137 Brisbane Grove Road Gateway Determination Review

PP-2024-291

Advice Report

Subject: Request for Gateway determination review – referral to Independent Planning Commission

Figure 3 – Road access map (source: Brisbane Grove Road Planning Proposal - Flood Assessment, Rhelm December 2023)

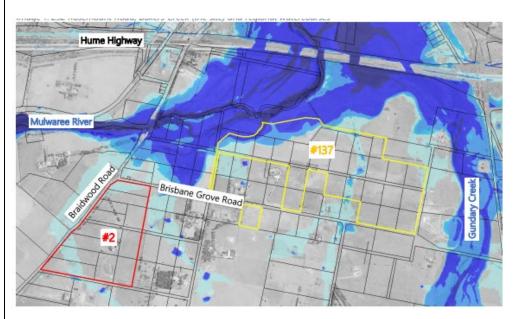
The Flood Impact and Risk Assessment Rhelm 2023 (**Attachment EC**) which was prepared in support of the planning proposal identifies that Braidwood Road, which is the only access and evacuation route from the site to the Goulburn urban area becomes inundated to a hazardous extent for 23 hours during a 1% AEP flood, 38 hours during the PMF and that isolation of the site can occur during events rarer than 5% AEP (**Figure 3 – Road access map**)

Figure 3 – 1% AEP Event – Flood Depth/Levels/Flood Hazard (Source: GRC Hydro FIRA)

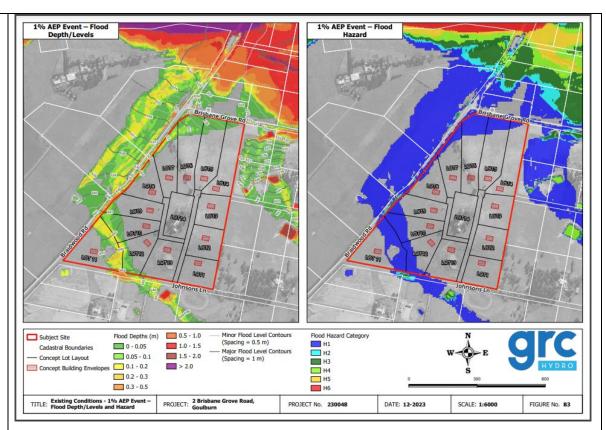
The planning proposal identifies that whilst all dwellings will be flood free up to and including a PMF event, residents are likely to be isolated in their homes (and immediate surrounds) for an extended period of time, because the limited available flood warning times for floods at the 1% AEP or rarer events in the local catchment would largely rule out self-evacuation as a suitable emergency management response during these flood events. The FIRA identifies that Braidwood Road is expected to be hazardous for crossing during this time as shown in Figure 3 below.

In assessing whether the period of isolation for future dwellings on the site during flood events, the Department referred to the draft "Shelter-in-Place Guidelines" as an indicative guide. The draft Guideline, which was placed on public exhibition from January 2023 until February 2023, recommended that occupants should not shelter-in-place for more than six hours.
